Docket Item # 4  
BAR CASE # 2011-0003

BAR Meeting  
February 23, 2011

**ISSUE:** Request for Approval of New Construction  
**APPLICANT:** Wanda Carter  
**LOCATION:** 219 North West Street  
**ZONE:** RB / Residential

Figure 2: Elevations  
Submission September 22, 2010 BAR Hearing

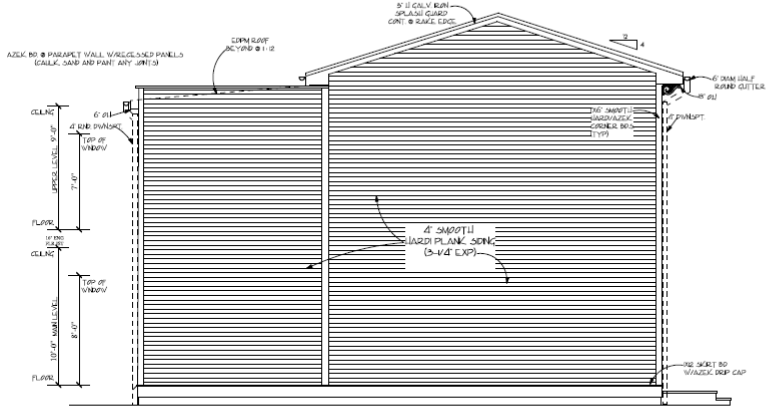
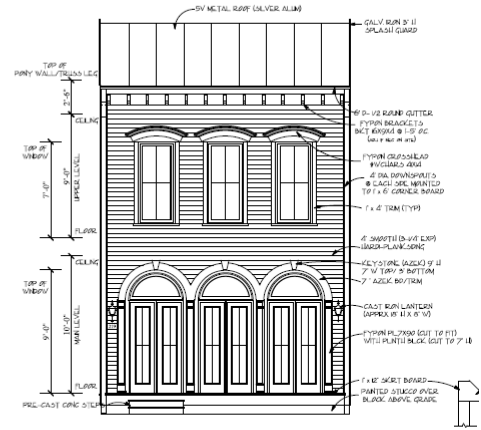
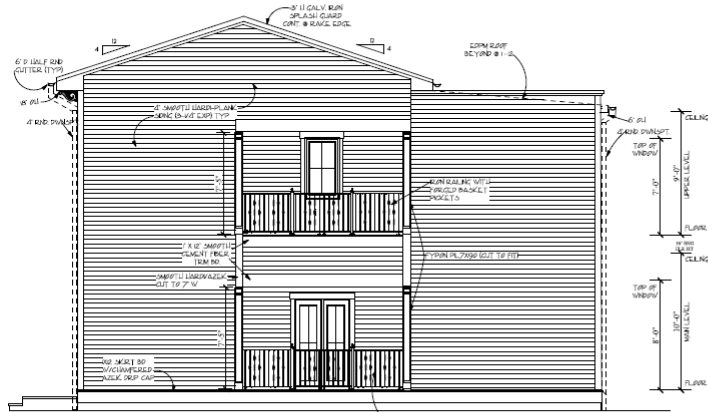
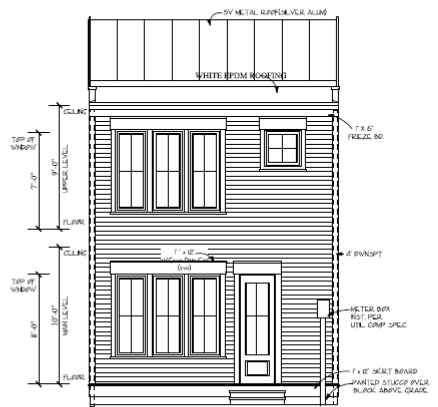
In order to move the previously approved dwelling to the rear of this shallow lot, the roof of the ell must be lowered to stay below the 1:1 rear yard setback slope required by the zoning ordinance. The applicant has, therefore, revised the side and rear elevations to eliminate the previous parapet wall (figure #2), exposed the low slope shed roof, and installed a large shed dormer. A row of four aluminum clad wood awning windows in the dormer align with the windows of the east wall below. An aluminum-clad-wood Velux roof window is also now shown in the east slope of the main roof. (figure #4)

**Figure 3: Site Plan Showing 8' Setback  
Submission February 23, 2011 BAR Hearing**

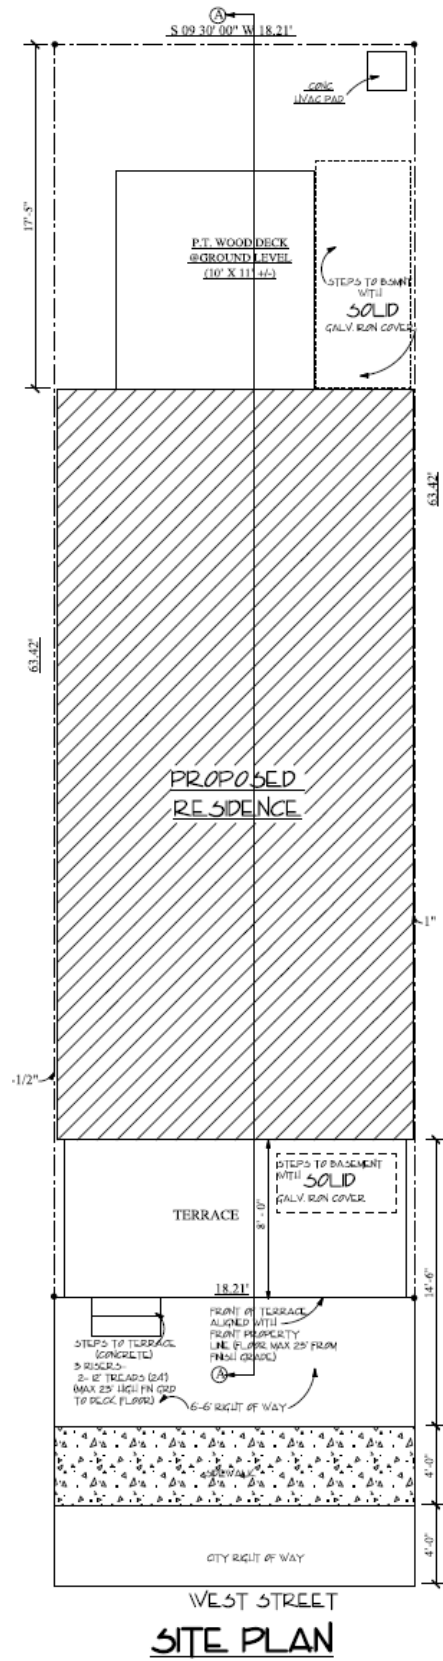
Upon further study, the applicant has returned to the Board to amend the previous approval of a dwelling and to shift the building toward the east 8'-0" in order to be in keeping with the setback of the adjacent houses and to provide a 23" tall, roofless front terrace. There is a wide variety of setbacks in this block of N. West Street. The zoning ordinance gives the BAR the authority to modify the front lot line "consistent with the character of the district..."

The Zoning Staff advises that the proposed alterations comply with zoning ordinance requirements, pending the BAR's finding that the proposed front lot line is consistent with the character of the district. In the BAR Staff's opinion, the requested setback is appropriate and consistent with this block face. An open front terrace surrounded by a balustrade was a common feature of early 20<sup>th</sup> century neo-Classical style dwellings and appropriate for the Italianate/neo-Classical style of this townhouse.

Figure 4: Elevations  
Submission February 23, 2011 BAR Hearing

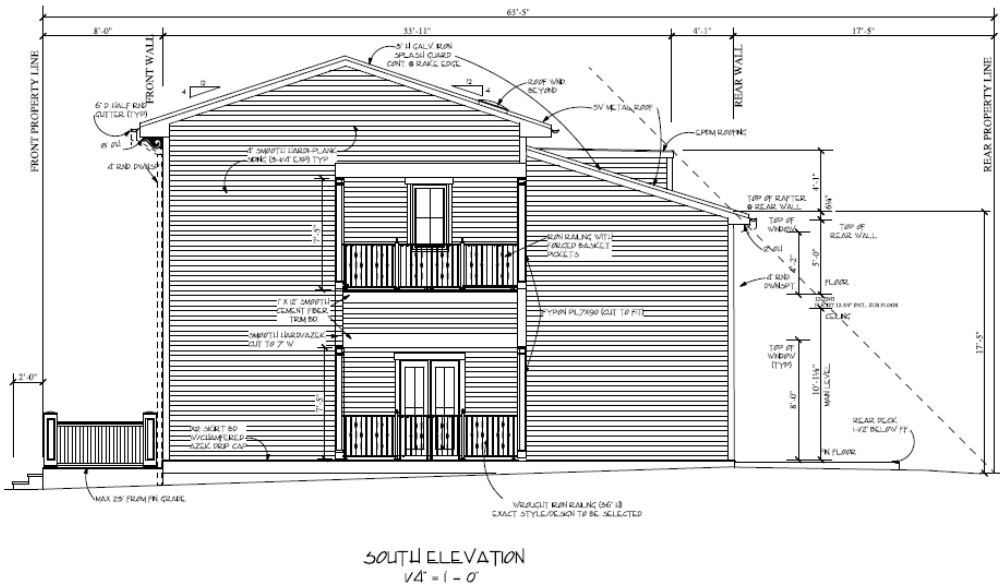
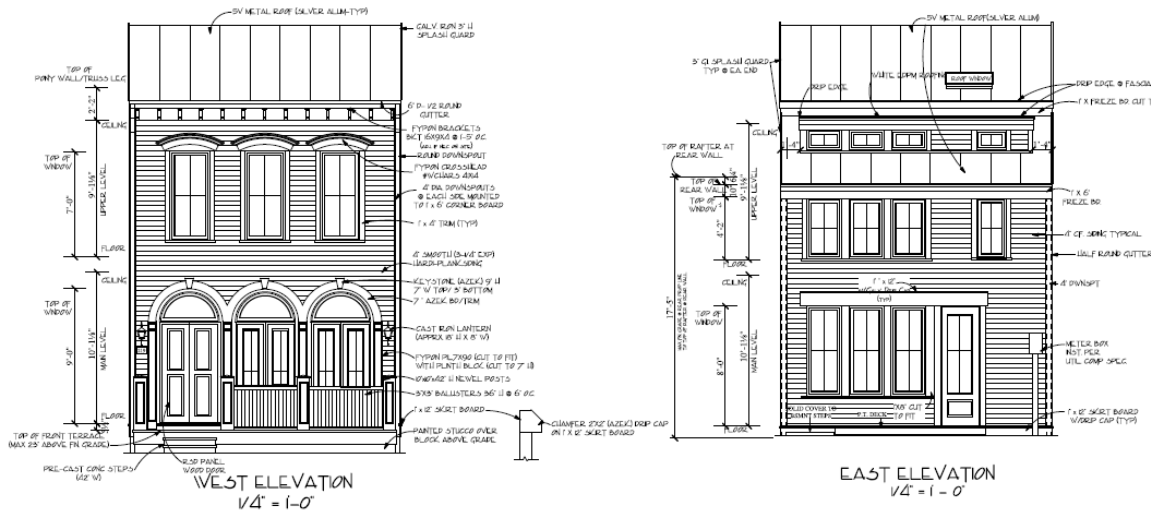
Staff supports the proposed composite decking for the terrace in this instance, as it is needed to hide a basement access hatch, but recommends that it be a traditional 1 x 4 tongue and groove pattern material to avoid the appearance of a suburban deck. Staff also recommends that the railing around the terrace be only 30" tall, as this was a more historically appropriate height and a 36" tall guardrail is not required by the building code in this location. More historically appropriate, neoclassical cap and base details are suggested for the newels, as well. Staff supports the custom made, natural finish wood door, as previously suggested by the Board, in order to better identify the location of the pedestrian entrance from the street.

Staff prefers the new shed roof of the ell and dormer because it is more consistent with the vernacular rear elevations of Parker Gray townhomes. However, Staff believes that the 4' tall second floor windows on the east elevation would be more functional for future occupants if the sills were raised above the floor. The building code requires window sash to be fixed if the sills are less than 18" above the floor. A 2' tall casement or awning

5. That the composite material of the terrace deck be a traditional 1x4 tongue and groove pattern.
6. That the height and details of the terrace railing be refined and approved by staff.

7. That the second floor windows on the east elevation may be shorter, as approved by staff.
